UNITED STATES PATENT AND TRADEMARK OFFICE

APPLICATION NO.	FILING DATE	FIRST NAMED INVENTOR	ATTORNEY DOCKET NO.	CONFIRMATION NO.
10/509,153	09/28/2004	Wai Yip Wai Wong	6018	5039
7590	12/14/2006			
Eric Chan 42 Pin Oaks Drive Phoenixville, PA 19460			EXAMINER LEE, LAURA MICHELLE	
			ART UNIT 3724	PAPER NUMBER
DATE MAILED: 12/14/2006

Office Action Summary

DETAILED ACTION

Figure 1

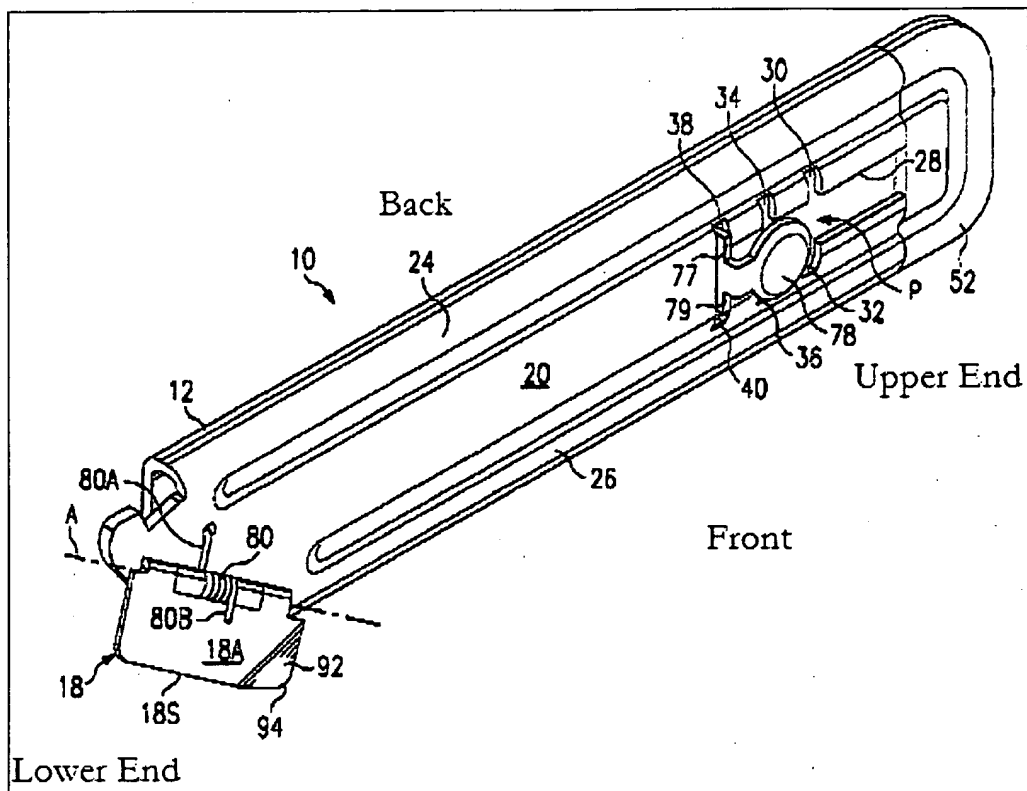
9. Claims 1-6 are rejected under 35 U.S.C. 102(e) as being anticipated by Davis (U.S. Patent 6,637,112). Figure 1 is provided below as an indicator of the various positional interpretations with regard to the Davis reference.

Davis discloses a safe knife sheath comprising a sheath body (handle, 12) and a blade support (keeper plate, 14); the blade support (14) is mounted inside the sheath body (12) and movable in a sliding motion; the front part of the sheath body has a push button (actuator button, 78); the lower part of the push button is connected to a

positioning element, (stub, 76); the lower part of the blade support has a positioning groove (slot, 56; that extends the entire length of the keeper plate, 14) corresponding to the positioning element (76); inside the sheath body (12), a positioning channel (indicated by P; Figure 10) is disposed on the top; on the top of the blade support (14) a positioning lobe (latch shoulders, 77/79) corresponding to the positioning channel (P) is disposed; the top of the push button (78) is connected to one end of a first reset spring (spring arm, 58; paragraph [0029]), and the other end of the first reset spring is fixed in the upper end of the sheath body; in the back of the blade support a trapezoidal piece (see Figure 2 below) is disposed; on the lower side of the trapezoidal piece a second reset spring (80) is disposed; one end of the second reset spring is fixed in the lower end of the sheath body and the other end is fixed on the inner side of the sheath body (see Davis Figure 1).

Figure 2

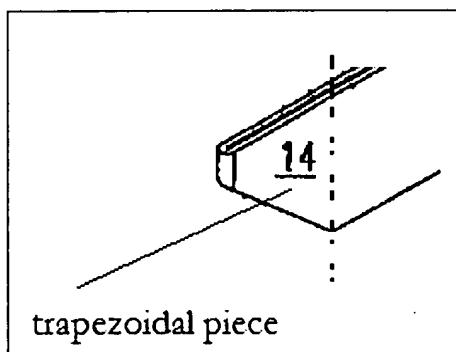
In regards to claim 5, Davis discloses wherein a plurality of holes (not numbered, the multiple legs of the C-shaped hole) is perforated in the front part of the sheath body.

In regards to claim 6, Davis discloses wherein the plurality of holes are elongated holes (see Davis Figures 1 and 2).
